FILE P.I. # 751420-
STP00-9252-00(007)
Fulton County
GDOT District 7 - Metro Atlanta
Johnson Ferry Road - Corridor Improvements

**DEPARTMENT OF TRANSPORTATION
STATE OF GEORGIA
PROJECT CONCEPT REPORT**

Roundabout Peer Review

Subject: RESPONSE TO ROUNDABOUT PEER REVIEW COMMENTS
Project No. STP00-9252-00(007)
P.I. No. 754120, Fulton County
COSS Project No. T-0011
Johnson Ferry Road and Glennridge Drive Connector Improvements

POTENTIAL STRIPING IMPROVEMENTS SANDY SPRINGS, GEORGIA

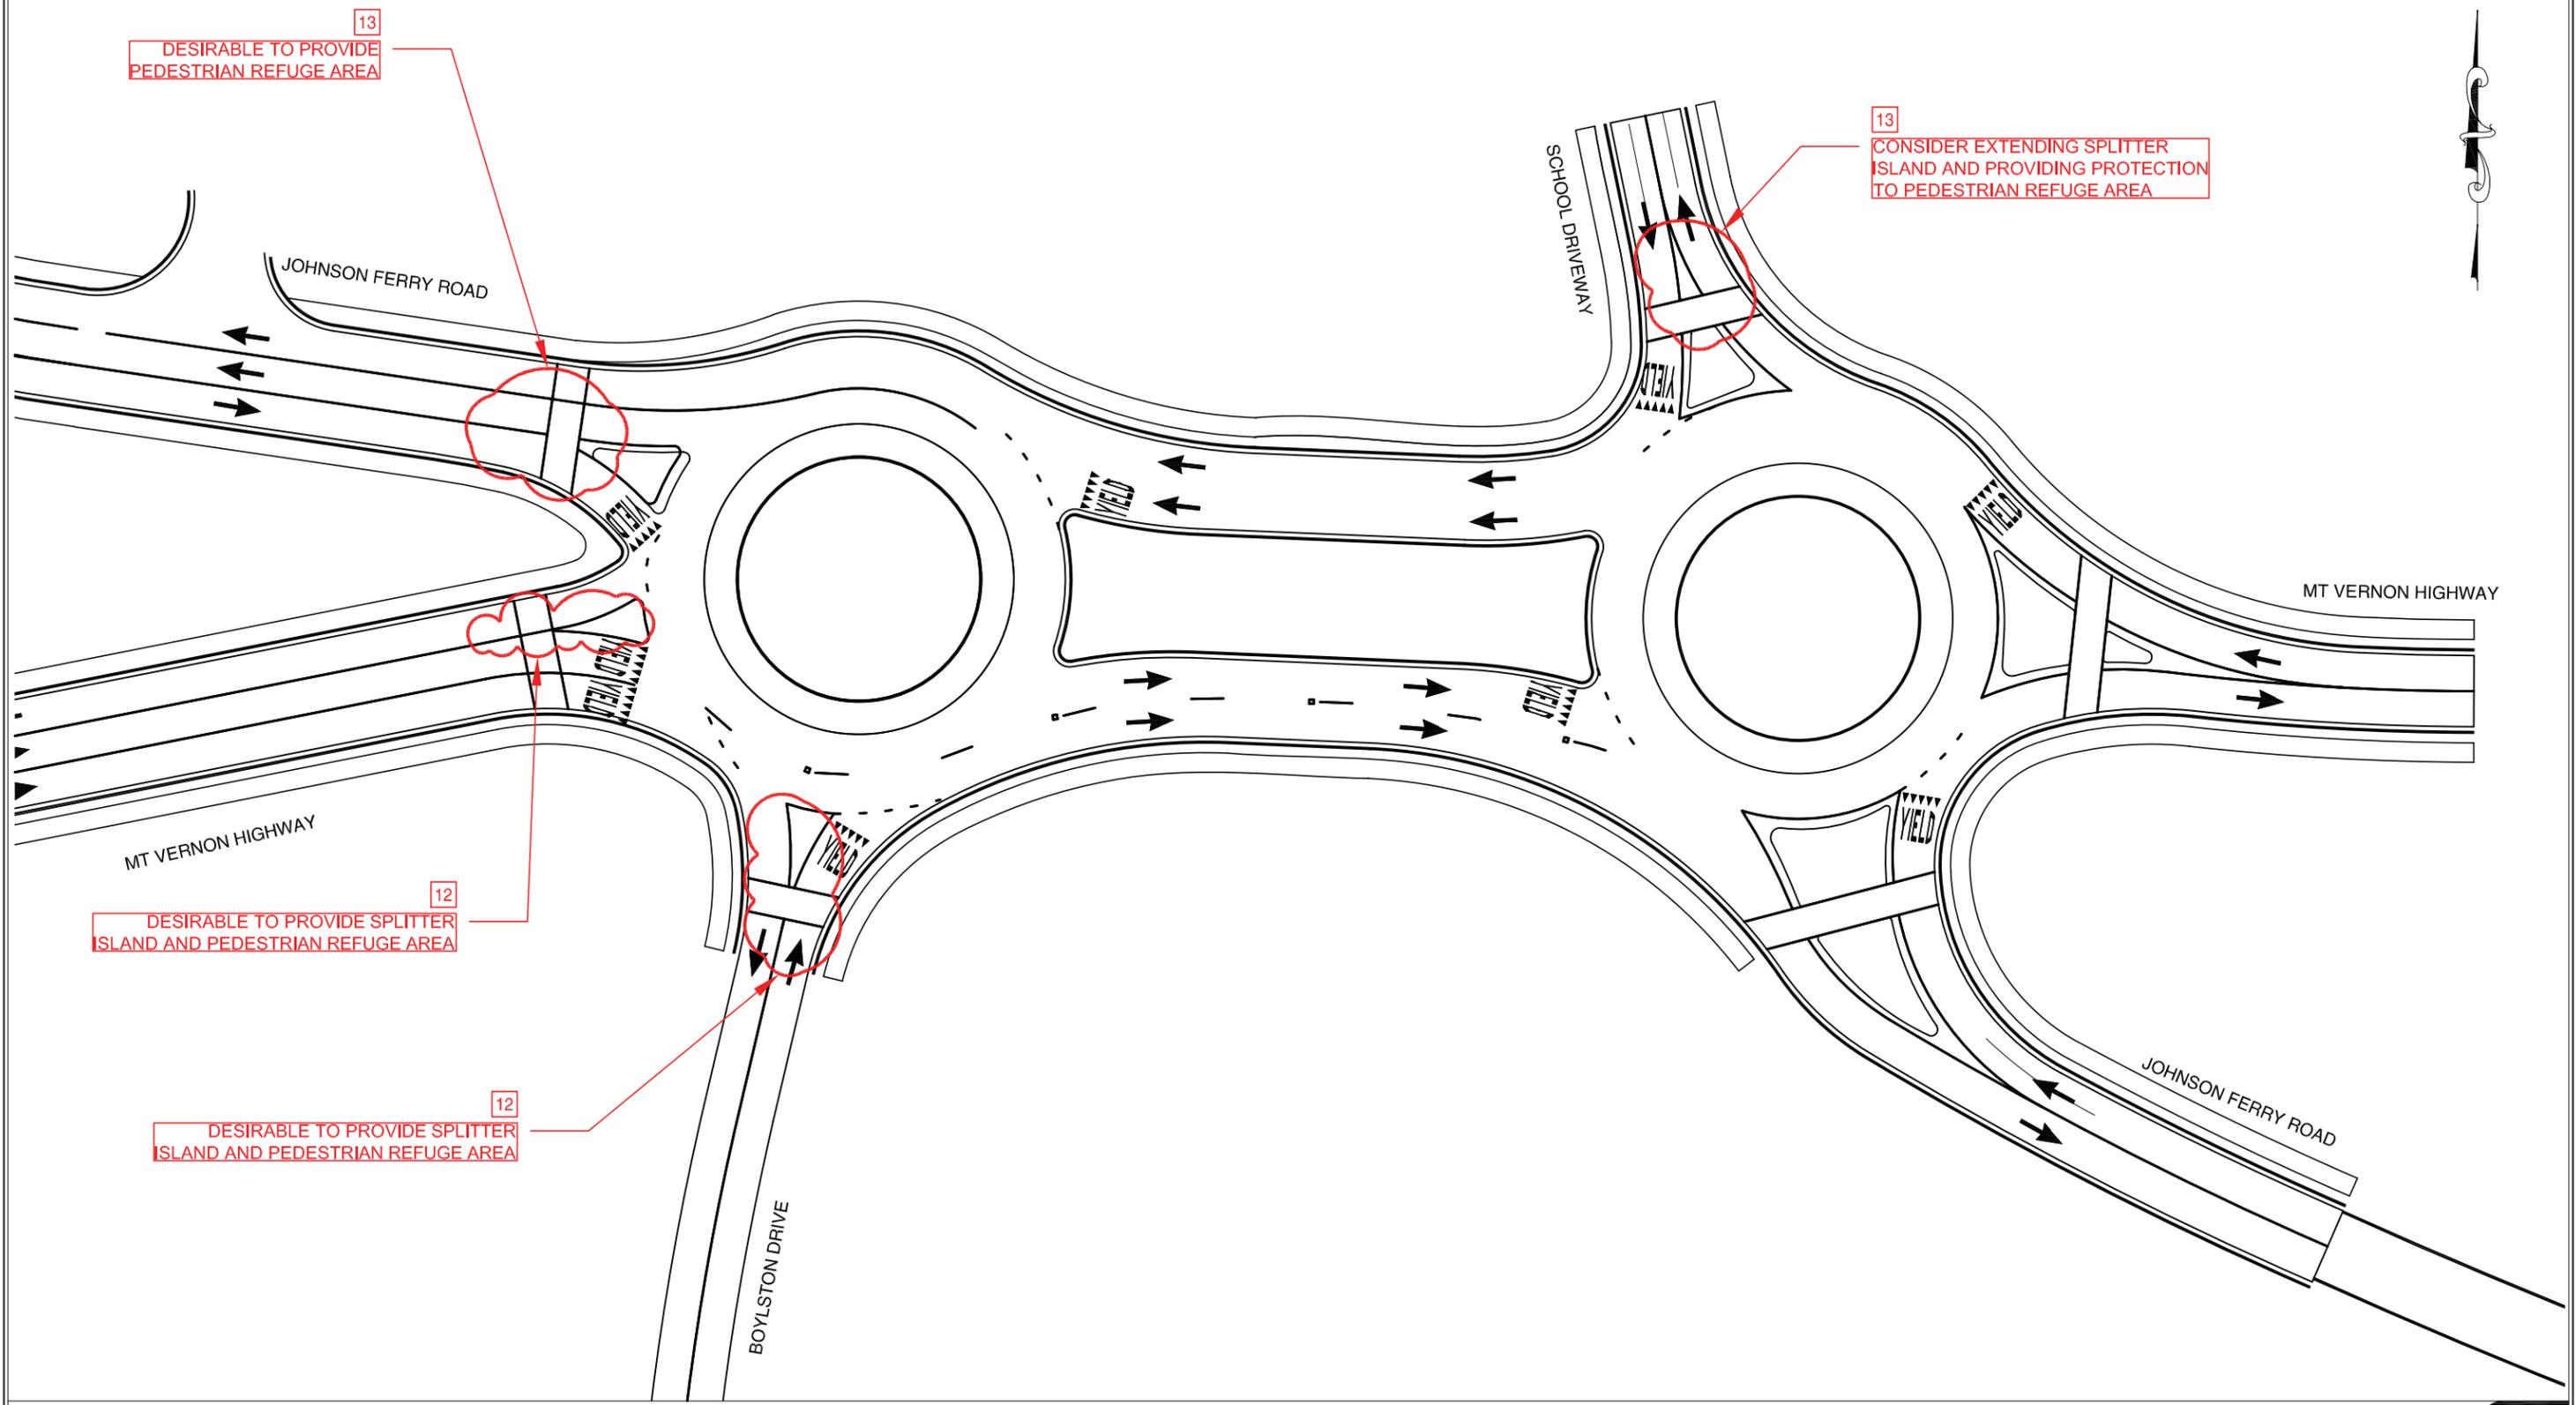
9. For all approaches, the dotted entrance line should extend across all entry lanes to meet the requirements of the 2009 Manual on Uniform Traffic Control Devices (MUTCD). If yield line markings are used, they should be staggered on the multilane entries to allow for improved driver visibility from both lanes.

10. Provide lane-use arrow markings on the circulatory roadways and approach lanes help clarify lane intended lane use.
11. Some striping appears to be missing from the provided design. The pavement markings play an important role in the operations of the multilane roundabouts and should be included as part of the horizontal concept design.

12. Splitter islands are not provided on two approaches at the western roundabout. Splitter islands provide pedestrian refuge area for safe and accessible pedestrian crossings, and prevent vehicles from making left-turns at the entries. It is essential that splitter islands and pedestrian refuge areas are provided. In particular, it is important for the eastbound entry of Mt. Vernon Highway to have raised splitter islands for speed control and for vehicle channelization. The two-lane entries and exits should be designed to allow possible pedestrian signalization to accommodate proposed draft rulemaking by the United States Access Board.

13. The splitter island on the southbound approach at the eastern roundabout is too short to provide physical protection to pedestrians in the refuge area. The splitter island on the eastbound approach on Johnson Ferry Road at the western roundabout ends before the crosswalk, leaving no pedestrian refuge area.

13
DESIRABLE TO PROVIDE PEDESTRIAN REFUGE AREA

12
DESIRABLE TO PROVIDE SPLITTER ISLAND AND PEDESTRIAN REFUGE AREA
